TM 11-5820-398-35

RADIO SET AN/PRC-25

CHANGE }
No. 1 }

HEADQUARTERS
DEPARTMENT OF THE ARMY
WASHINGTON, D.C., 17 September 1964

Figure 5. Tone squelch module A24, schematic diagram.

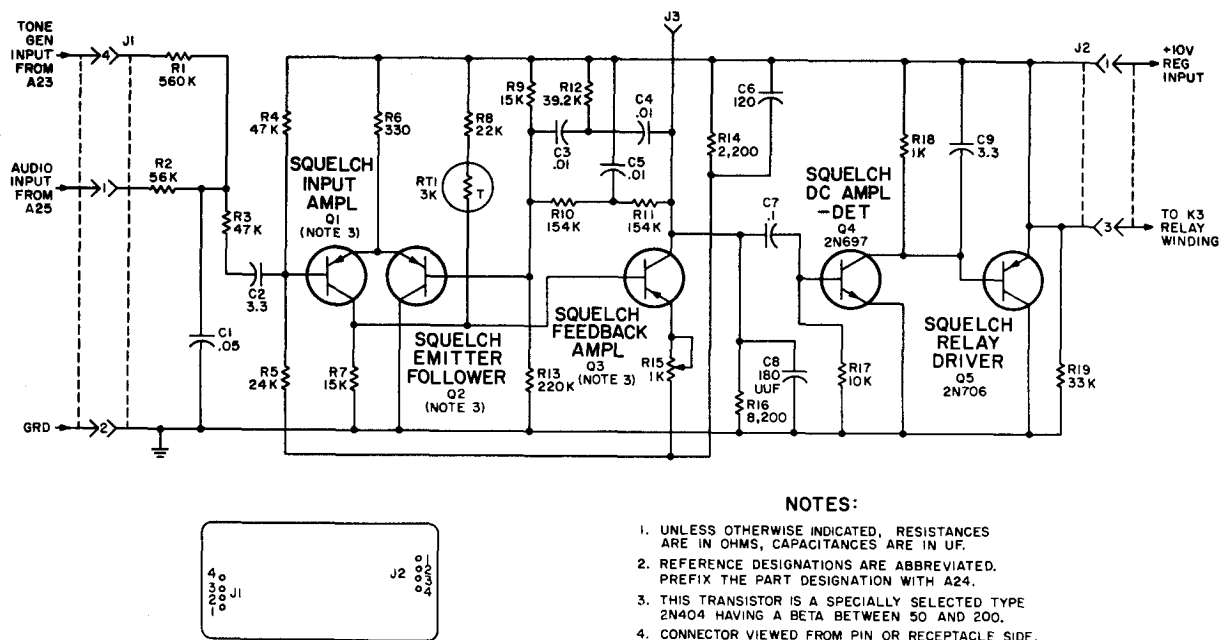
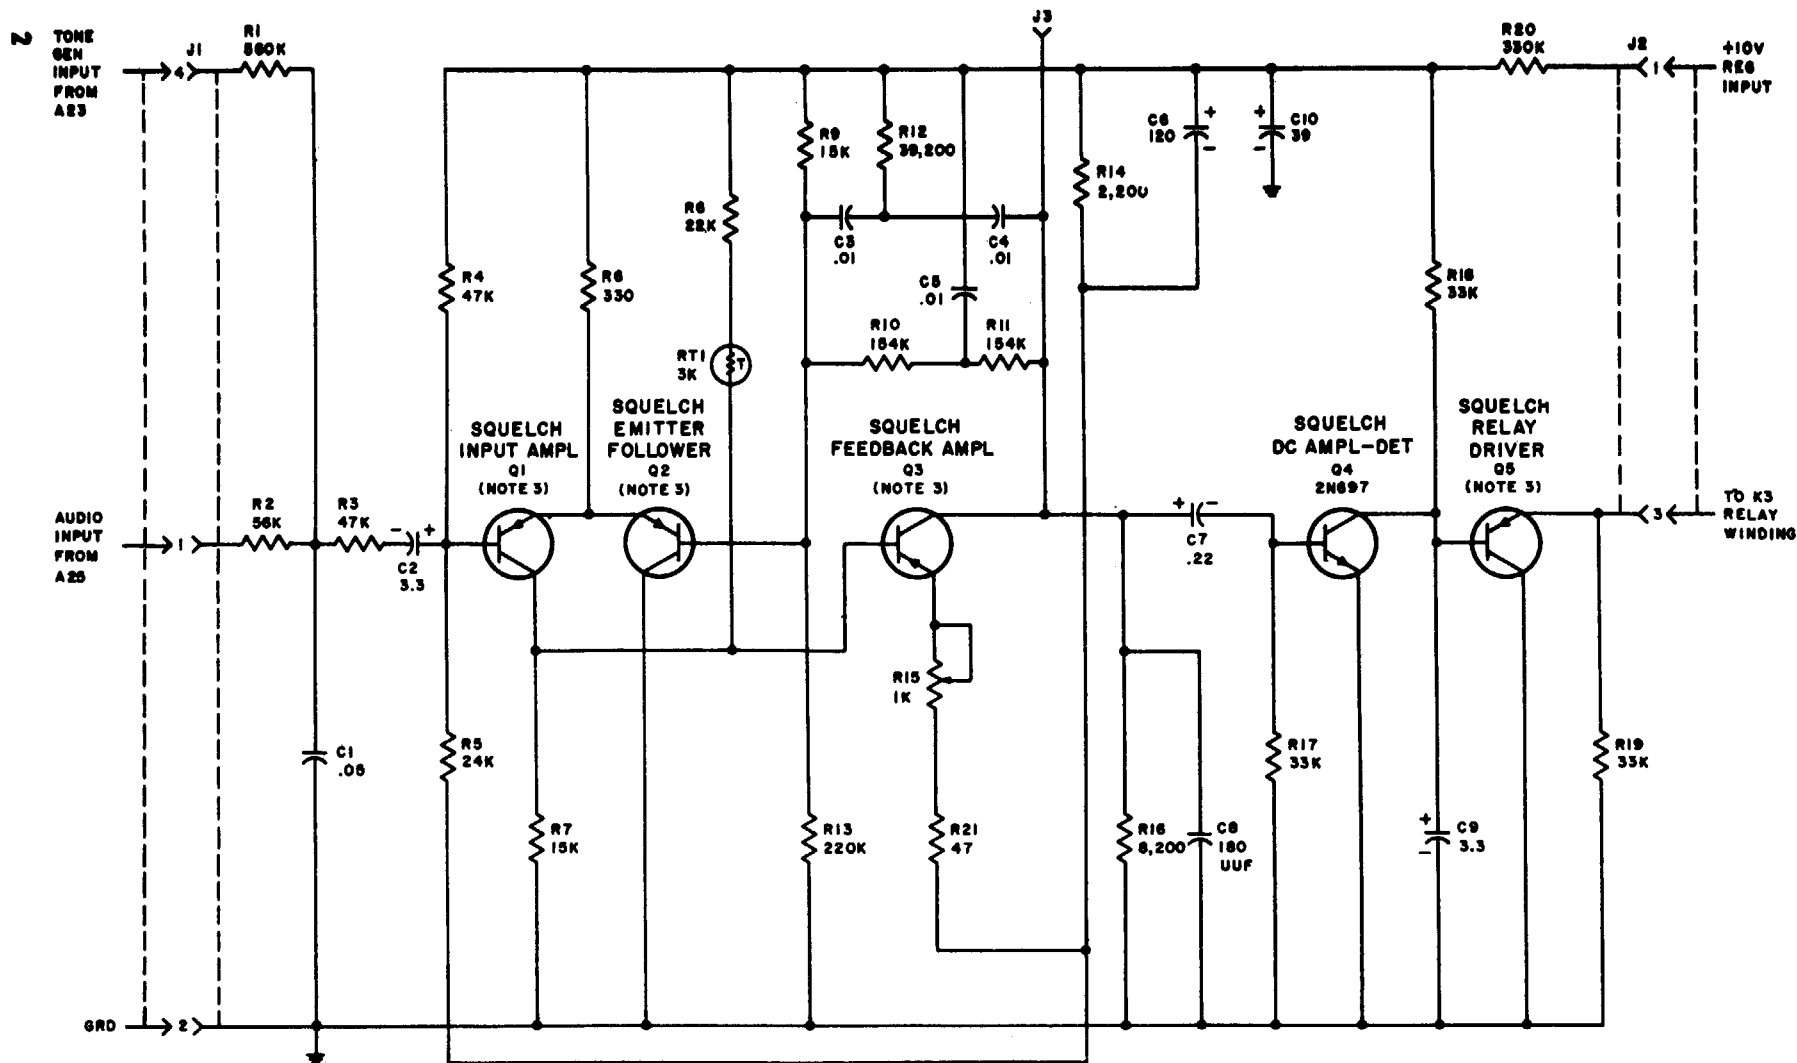
Page 14, figure 5. Make the following changes:

Change the value of C7 from .1 to 0.22 μ f.

Delete the connection between the emitter of Q5 and the +10V regulated input.

Near R12, add: (NOTE 5).

Change the figure caption to *Tone squelch module A24, early model, schematic diagram.*

Figure 6. Speech amplifier limiter module A22, schematic diagram.

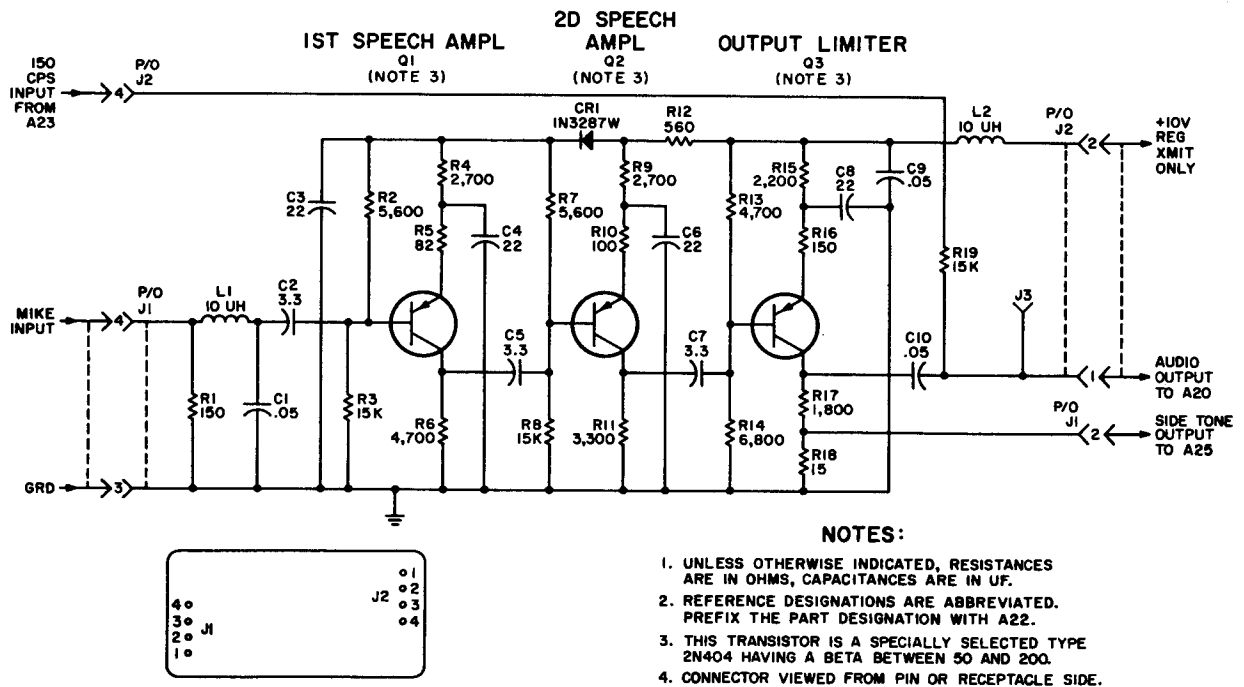
Page 15, figure 6. Make the following changes:

Change the value of R17 from 1,800 to 1,500 ohms.

Change the value of R18 from 15 to 220 ohms.

Figure 7. Tone generator module A23, schematic diagram.

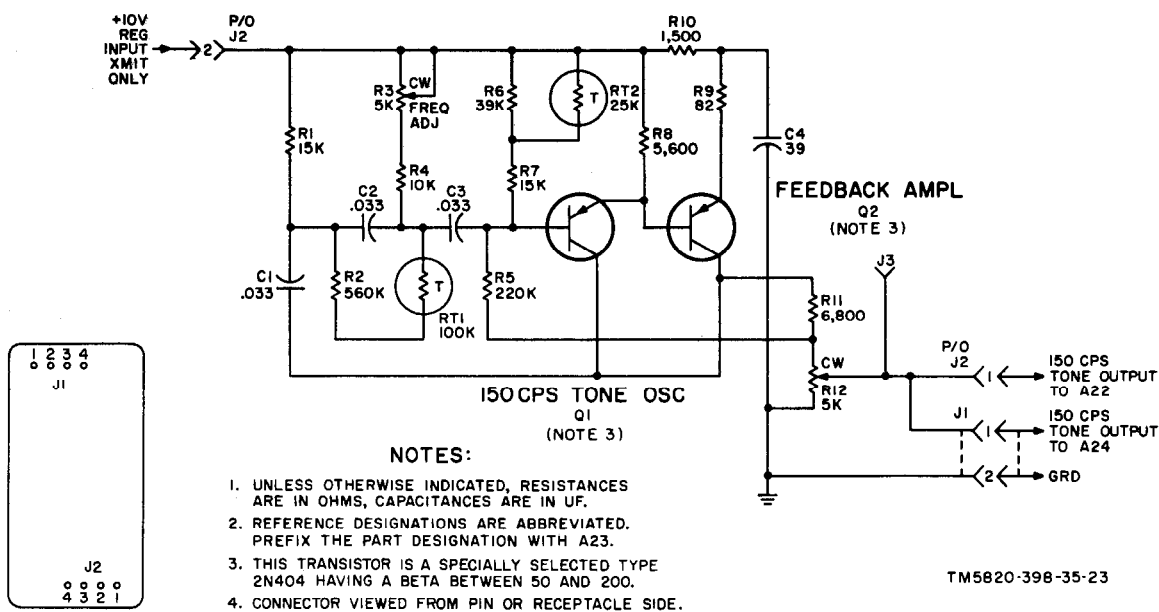
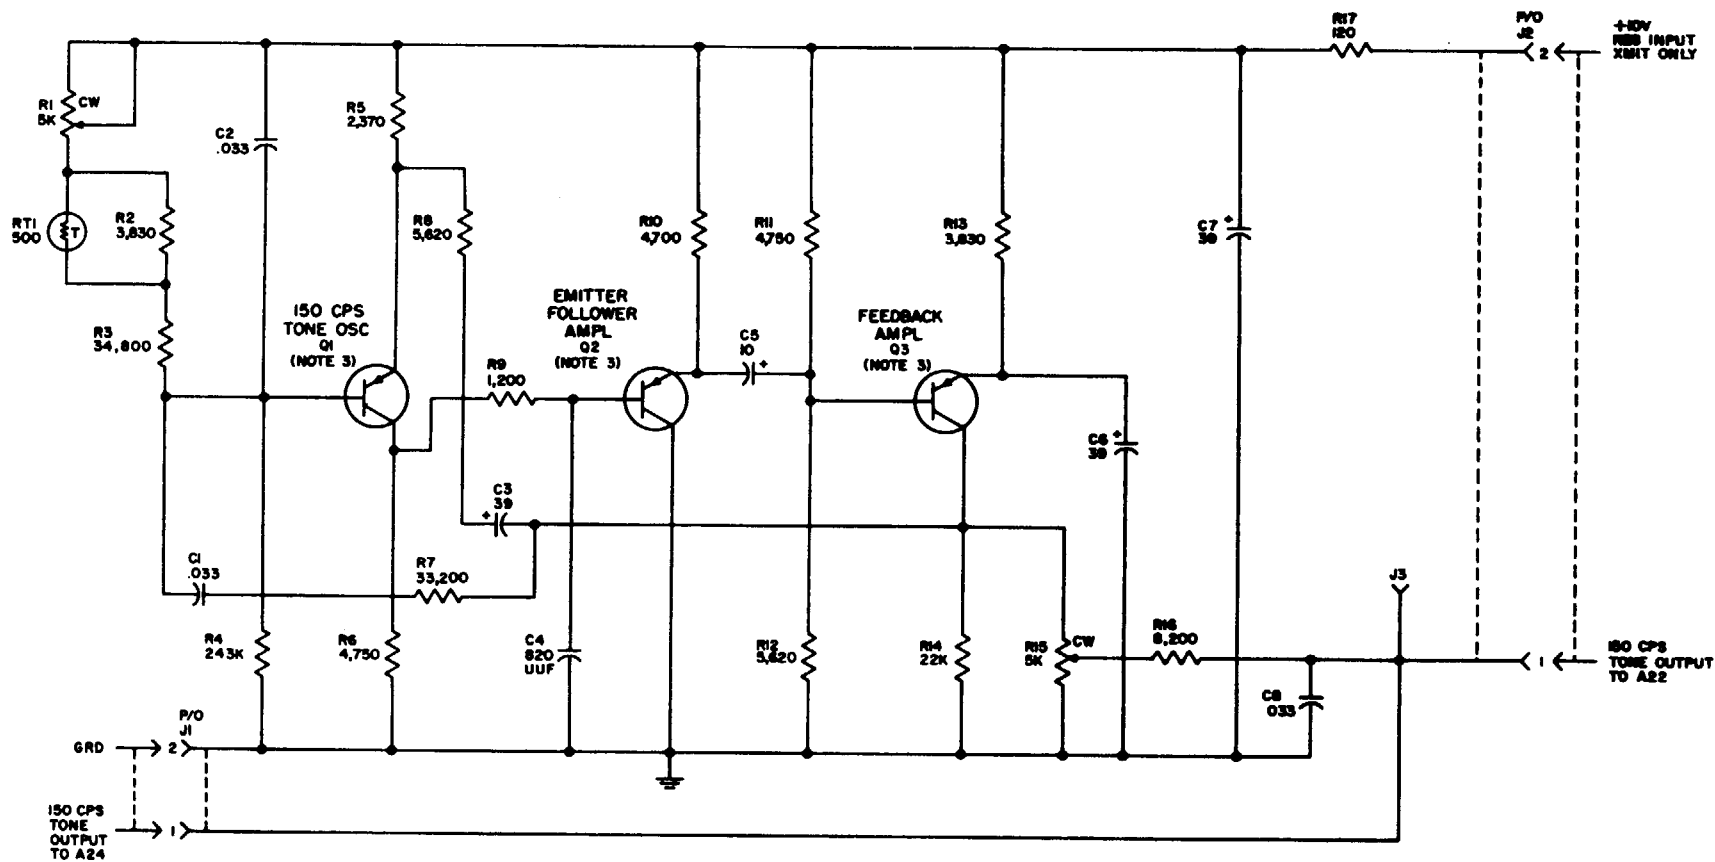
After figure 7, add figure 7.1.

Figure 8. Sidestep oscillator module A20, schematic diagram.

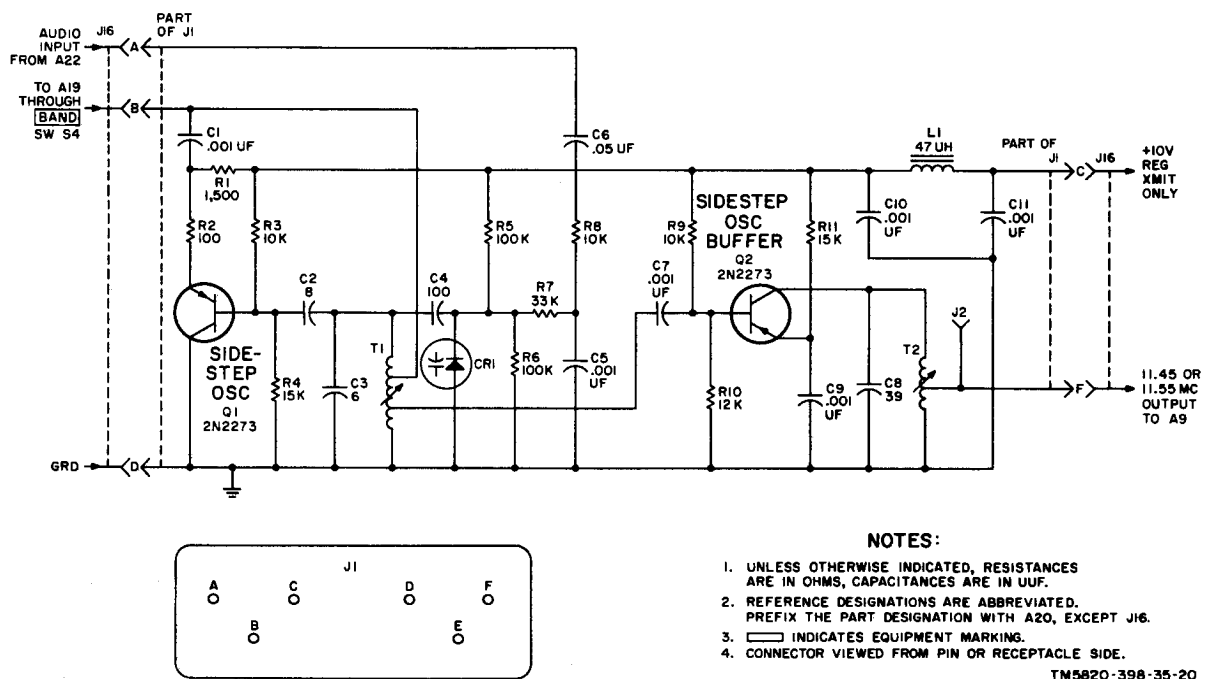
Page 18, figure 8. Make the following changes:

Near C9, add: (NOTE 5).

Paragraph 15a(3). After the first sentence, add: In late models, thermistor RT1 is connected parallel to R2 to prevent oscillator frequency instability due to temperature variations.

Figure 10. Variable frequency oscillator module A9, schematic diagram.

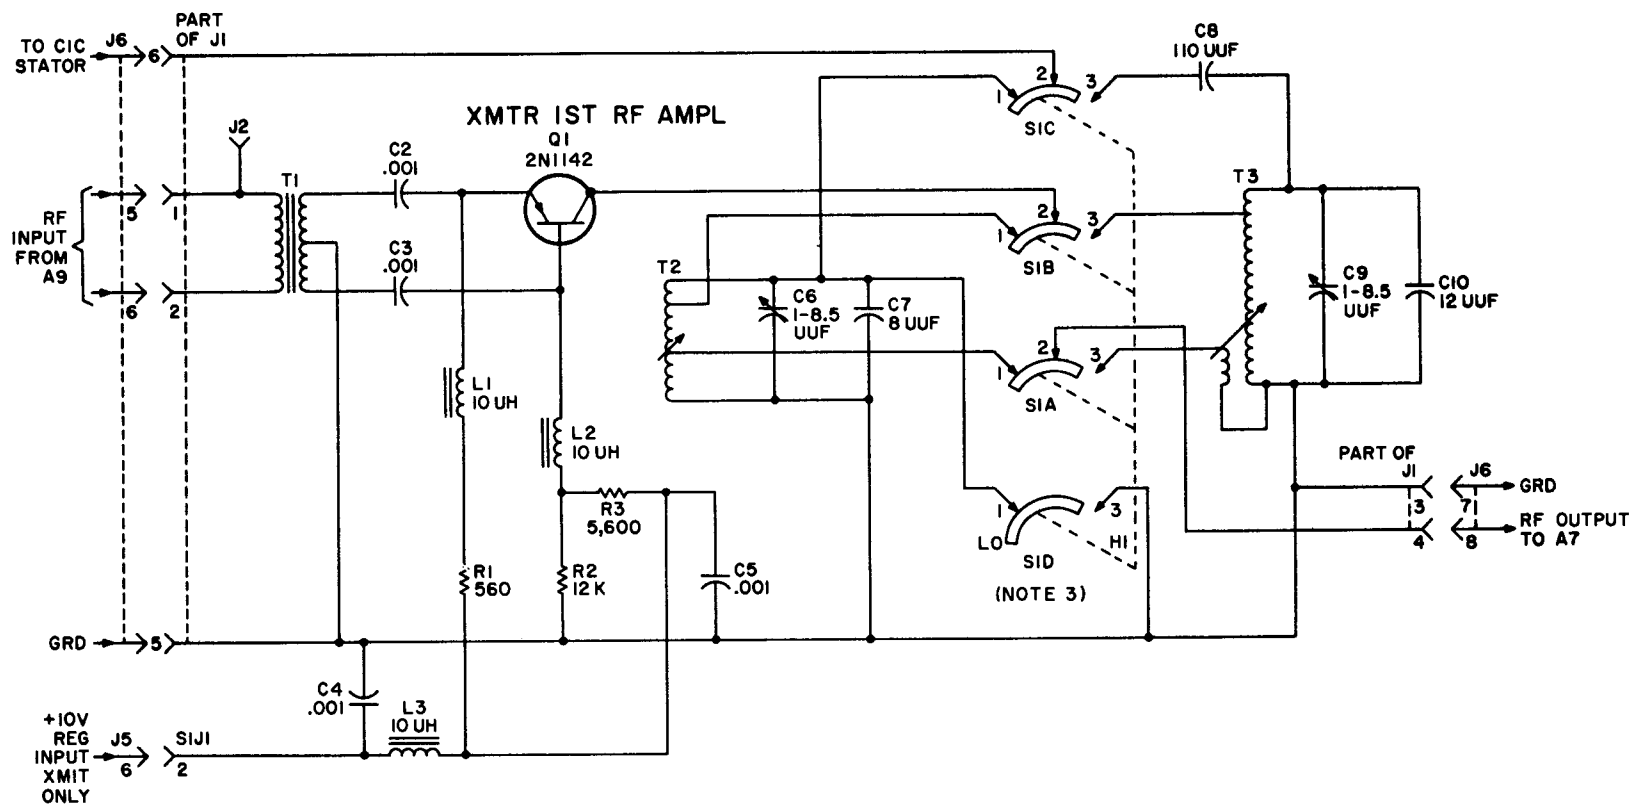
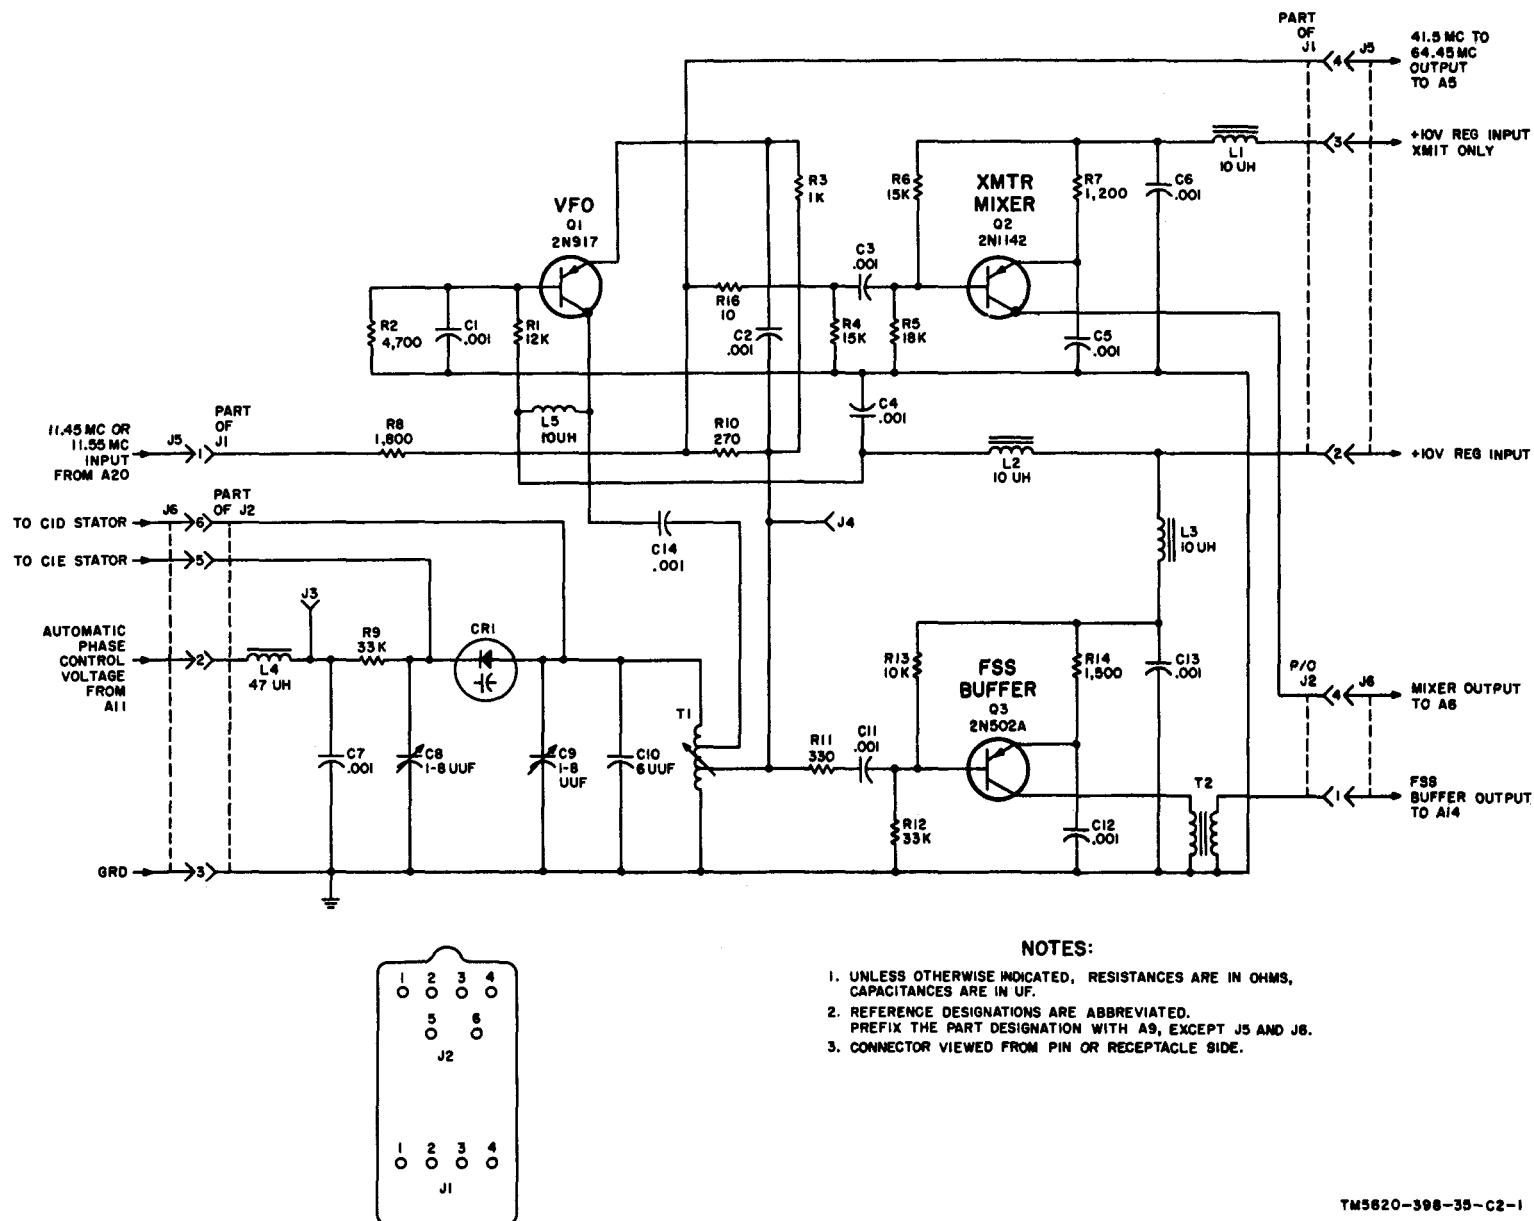
Page 20, figure 10. Make the following changes:

Near R16, add: (NOTE 4).

Near R2, add: (NOTE 5).

Figure 12. Transmitter second rf amplifier module A7, schematic diagram,

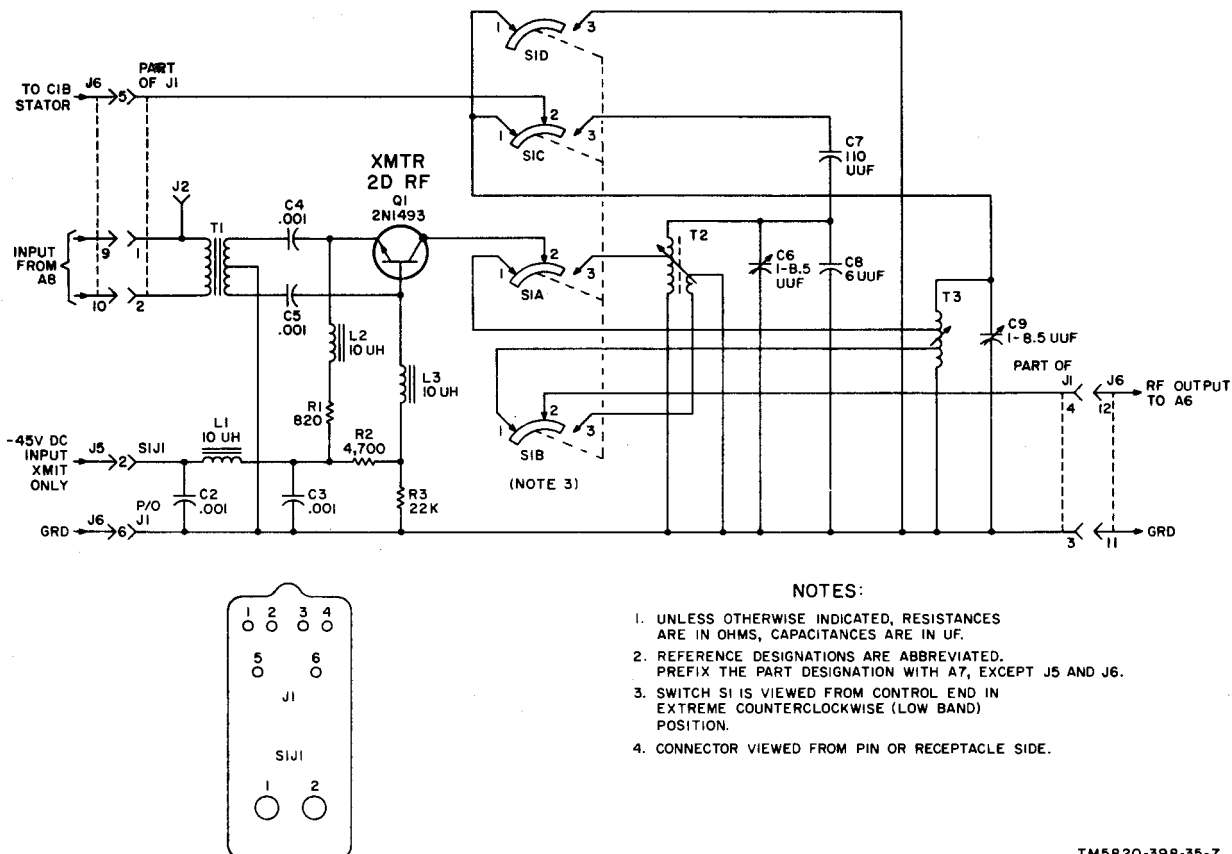
Page 22, figure 12. Change the value of R1 from 820 to 390 ohms.
